CITY OF WASHINGTON, ILLINOIS
Committee of the Whole Agenda Communication

Agenda Item: Trails Edge Section 9 and 10 Alternate Typical Section

Re: Trails Edge Sec. 9 Alternate Typ. Section Request

Re: Trails Edge Sec. 9 100YR Flood Option Analysis

ROADWAY TYPICAL SECTION RESIDENTIAL STREET (MINOR)

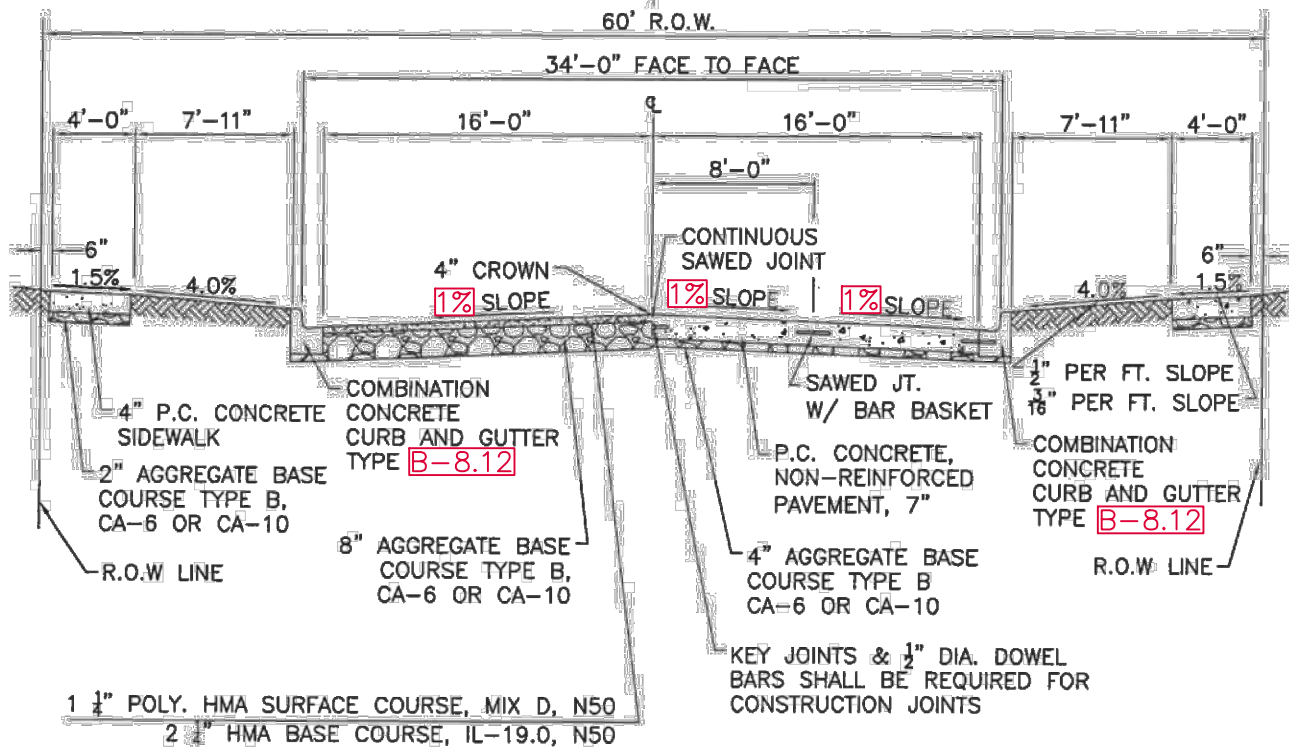
The proposed profile of Debate Street and the proposed intersection of Debate Street and Stephanie Court were designed to minimize the depth of water at the curb. This being the case, the standard typical City of Washington Typical Section would have water at a depth of 10" at the curb and by reducing the cross-slope from 2% to 1% and by increasing the curb height from 6" to 8" we can convey the 100YR flood water without exceeding the top of curb.

By using a combination of a 1% cross slope for the proposed road and 8" tall curb we are able to meet the 100YR flood requirements set forth by the City of Washington.

Explanation: Potential developers for the Trails Edge Section 9&10 property have recently been in contact with City Staff about drainage concerns. With the topography of this property, the existing drainage, and the increase in rainfall intensity design guidelines, the 100-year flood route was exceeding the curb line in a few low areas of the proposed roadway. The City's Stormwater ordinance allows for the 100-year flood route to be in the roadway, but it cannot exceed the height of the curb. To keep the water inside the curb, the cross slope of the roadway was reduced from 2% to 1% and the curb height was increased from 6" to 8".

ULTIMATE GRADING PLAN

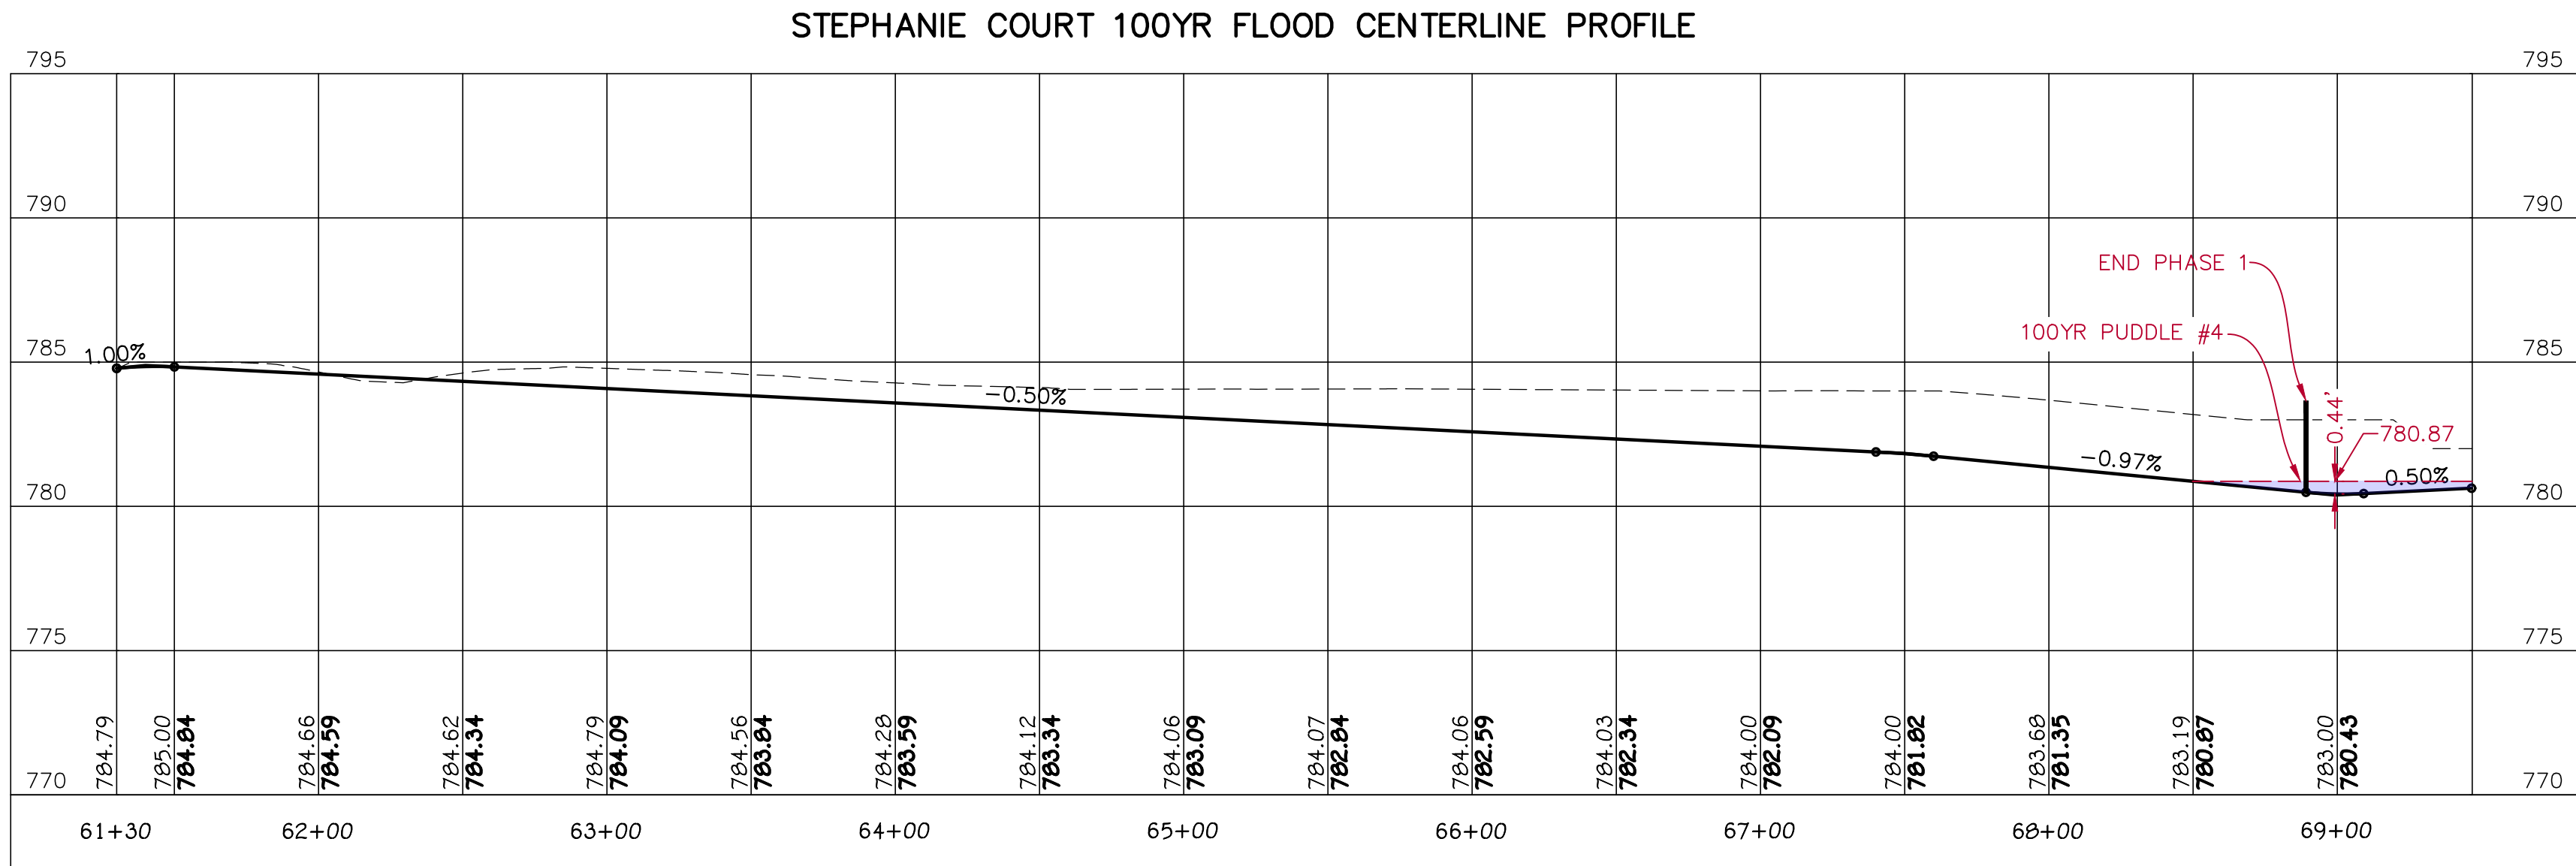
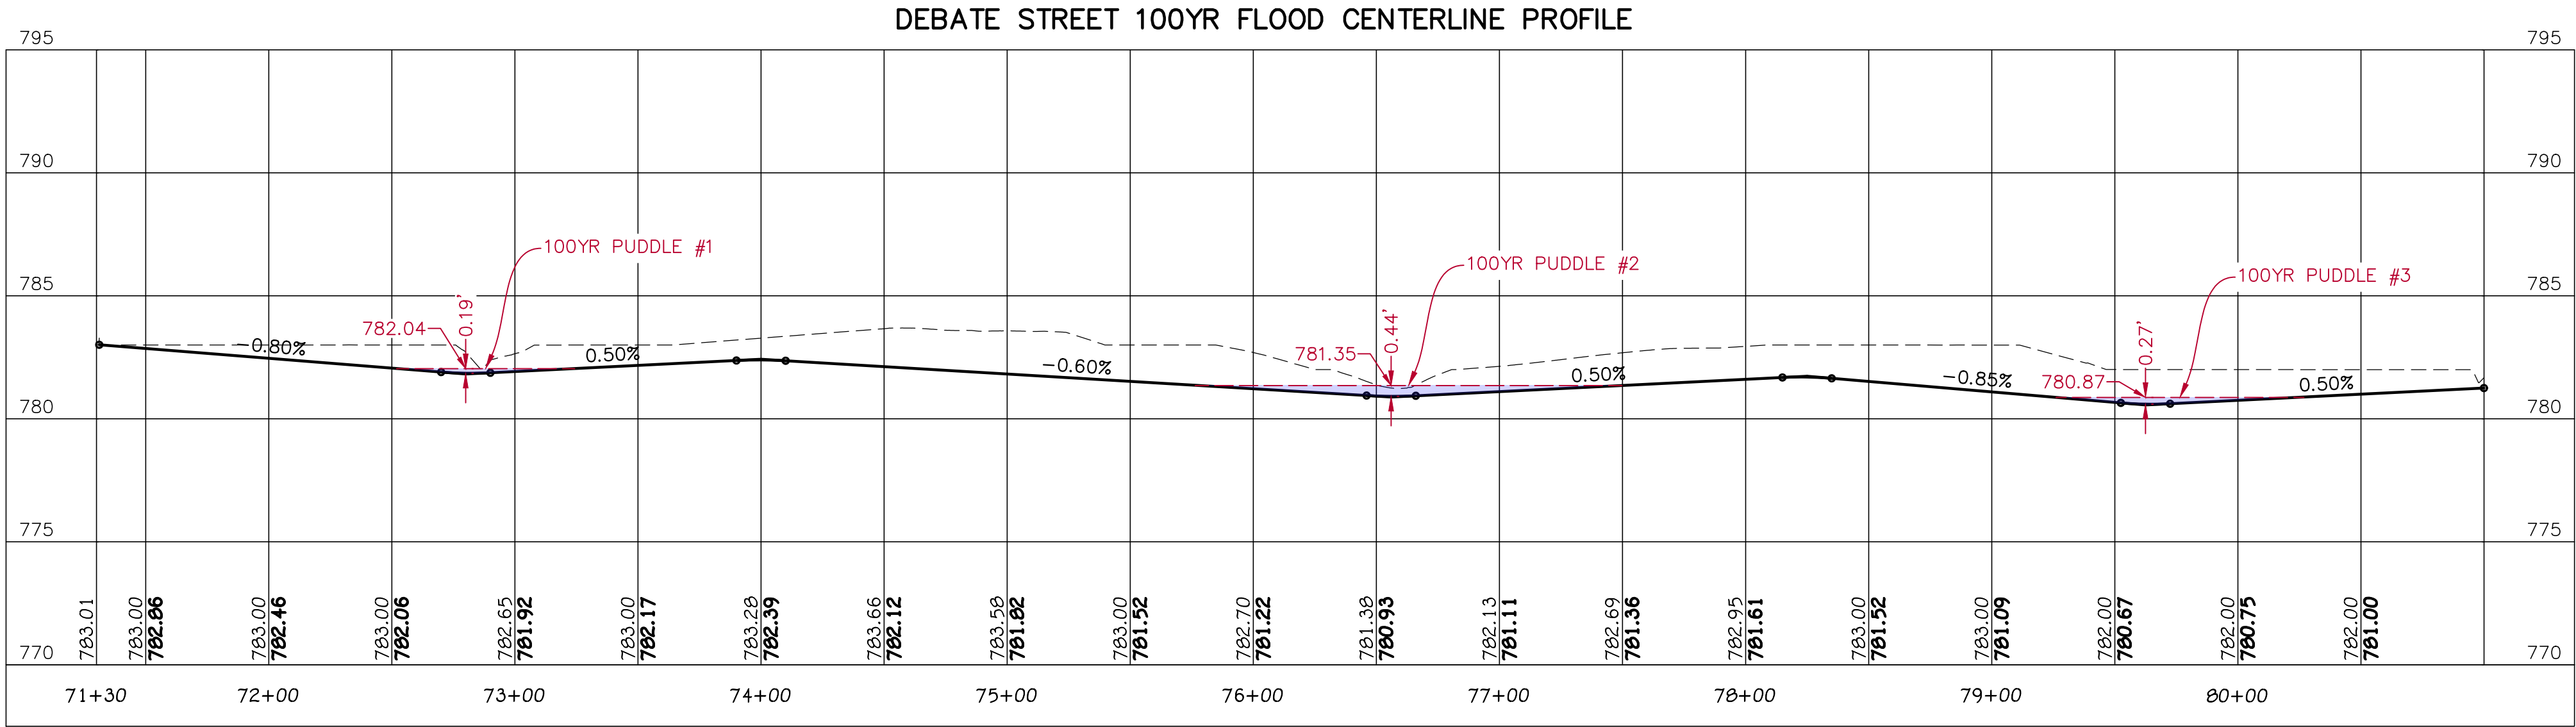
100YR FLOOD SUMMARY:

- 100YR PUDDLE #1:
TOP OF WATER ELEVATION = 782.04
DEBATE STREET CENTERLINE ELEVATION = 781.85
DEBATE STREET ELEVATION AT FLOW LINE = 781.63
HEIGHT OF WATER AT CENTERLINE = 0.19' = 2.28"
HEIGHT OF WATER AT FLOW LINE = 0.41' = 4.92"

- 100YR PUDDLE #2:
TOP OF WATER ELEVATION = 781.53
DEBATE STREET CENTERLINE ELEVATION = 781.09
DEBATE STREET ELEVATION AT FLOW LINE = 780.87
HEIGHT OF WATER AT CENTERLINE = 0.44' = 5.28"
HEIGHT OF WATER AT FLOW LINE = 0.66' = 7.92"

- 100YR PUDDLE #3:
TOP OF WATER ELEVATION = 780.87
DEBATE STREET CENTERLINE ELEVATION = 780.60
DEBATE STREET ELEVATION AT FLOW LINE = 780.38
HEIGHT OF WATER AT CENTERLINE = 0.27' = 3.24"
HEIGHT OF WATER AT FLOW LINE = 0.49' = 5.88"

- 100YR PUDDLE #4:
TOP OF WATER ELEVATION = 780.87
STEPHANIE COURT CENTERLINE ELEVATION = 780.43
STEPHANIE COURT ELEVATION AT FLOW LINE = 780.21
HEIGHT OF WATER AT CENTERLINE = 0.44' = 5.28"
HEIGHT OF WATER AT FLOW LINE = 0.66' = 7.92"
